Form 3160-5
(June 2019)UNITED STATES
DEPARTMENT OF THE INTERIOR
BUREAU OF LAND MANAGEMENTFORM APPROVED
OMB No. 1004-0137
Expires: October 31, 2021**SUNDRY NOTICES AND REPORTS ON WELLS**
Do not use this form for proposals to drill or to re-enter an abandoned well. Use Form 3160-3 (APD) for such proposals.

8. Well Name and No. HAWK 35 FED/403H

EOG respectfully requests an amendment to our approved APD for this well to reflect the following changes:

Hawk 35 Fed 511H (FKA 403H) API #: 30-025-48032

WELL LOCATION AND ACREAGE DEDICATION PLAT

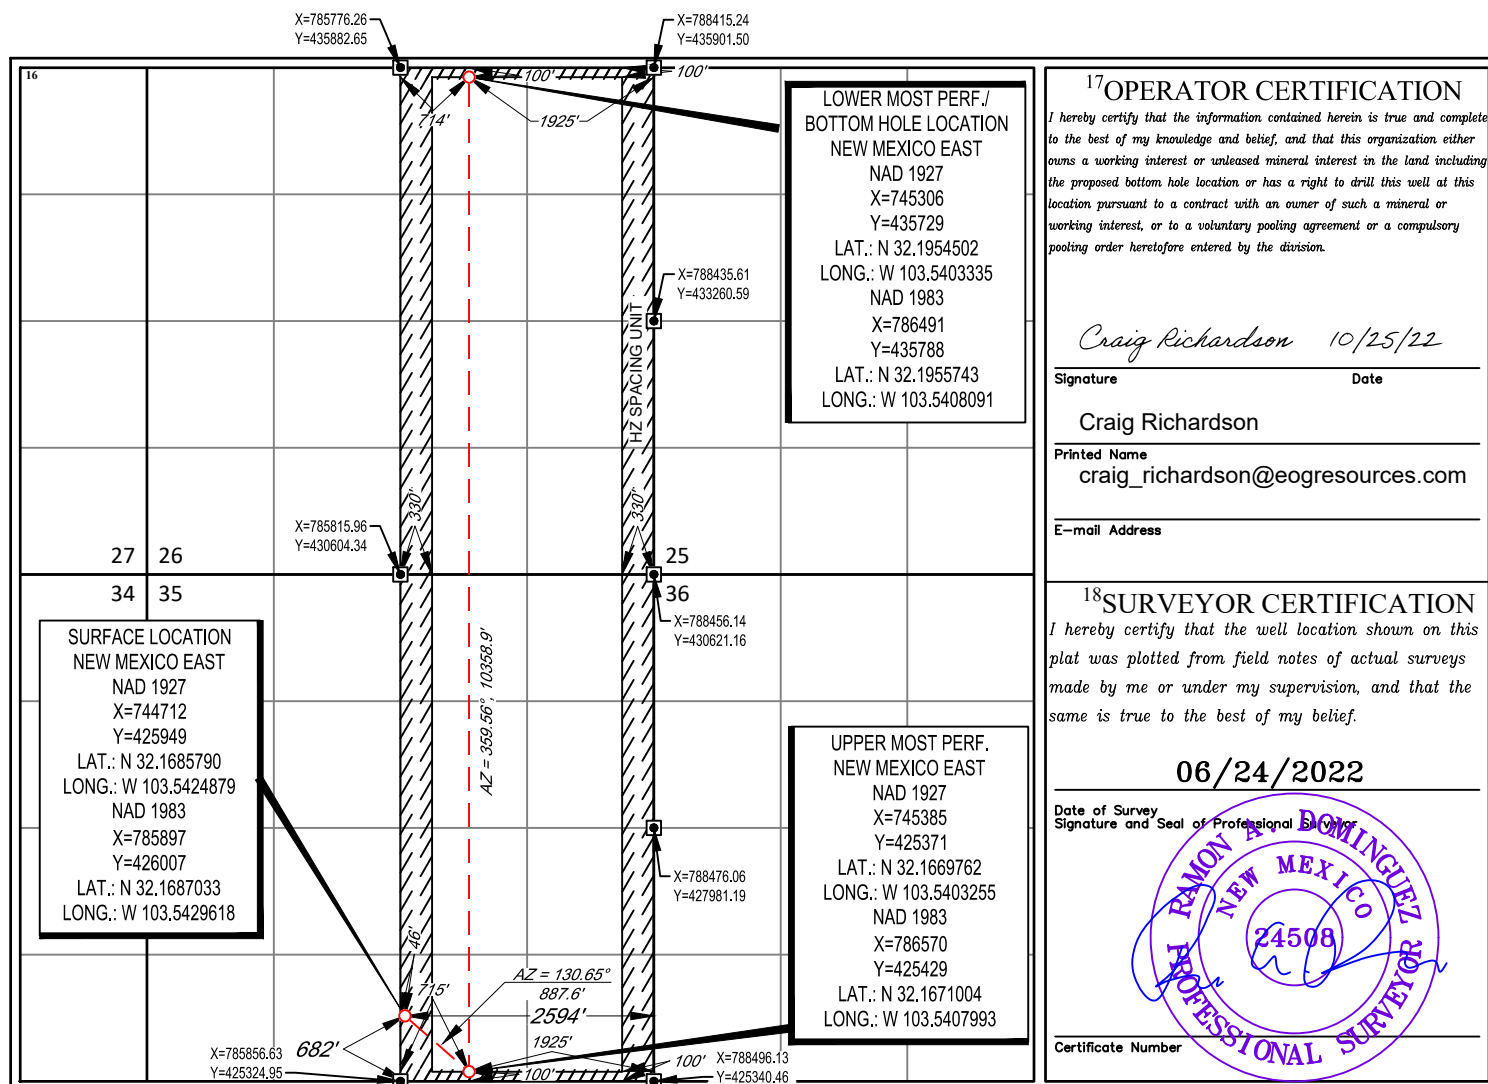
Change name from Hawk 35 Fed 403H to Hawk 35 Fed 511H.

Change BHL from T-24-S, R-33-E, Sec 26, 100' FNL, 1980' FWL, Lea Co., NM,
to T-24-S, R-33-E, Sec 26, 100' FNL, 1925' FEL, Lea Co., N.M.

Change target formation to Second Bone Spring Sand.

UL or lot no.	Section	Township	Range	Lot Idn	Feet from the	North/South line	Feet from the	East/West line	County
B	26	24-S	33-E	-	100'	NORTH	1925'	EAST	LEA
